MANUFACTURED HOUSING CONSENSUS COMMITTEE

MHCC Proposed Changes 2016-2017 Cycle and Non-Log Items

April 20, 2018

Figure 1. U.S. Air Freezing Index Map (based on Steurer, 1989 and Steurer and Crandell, 1995)

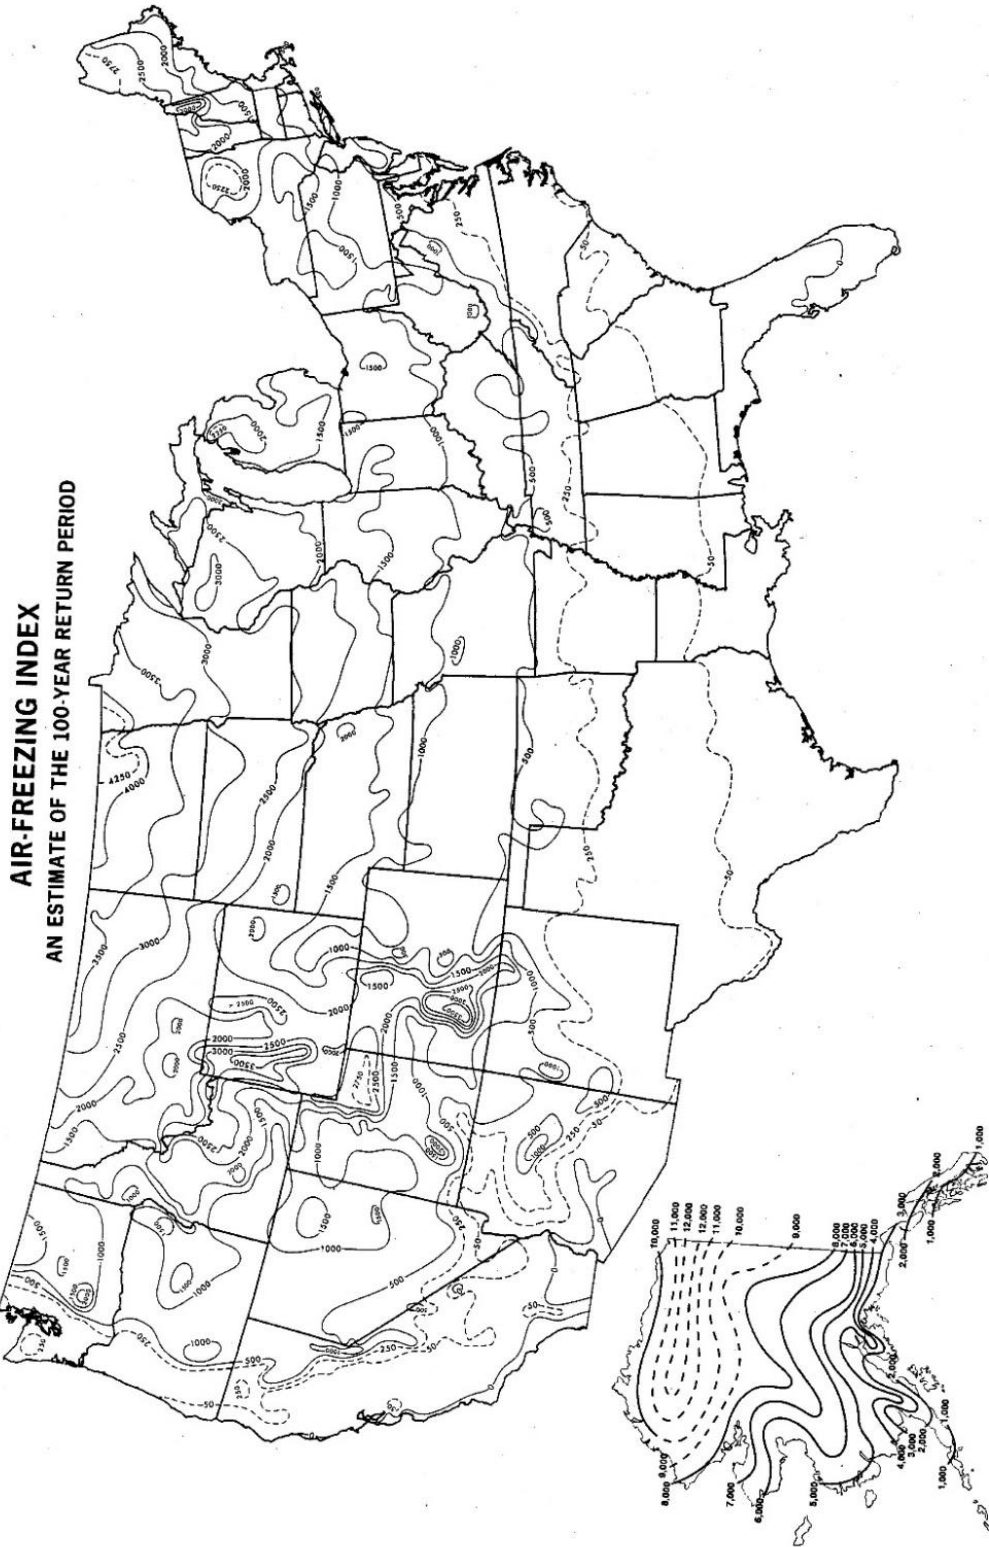
- Obtain the local-design frost depth for footings from either one of the following:
 - The local authority having jurisdiction (LAHJ),
 - Use Table 1 with the site's Air-Freezing Index (AFI) from Figure 1¹, or

- Consult with a registered professional engineer, registered architect, or registered geologist.
- When using Table 1 and Figure 1 to determine frost depth for footings, the depth of interior pier footings complying with footnote (b) of Table 1 may be taken as one-half the depth required in Table 1 ~~with approval of the LAHJ.~~
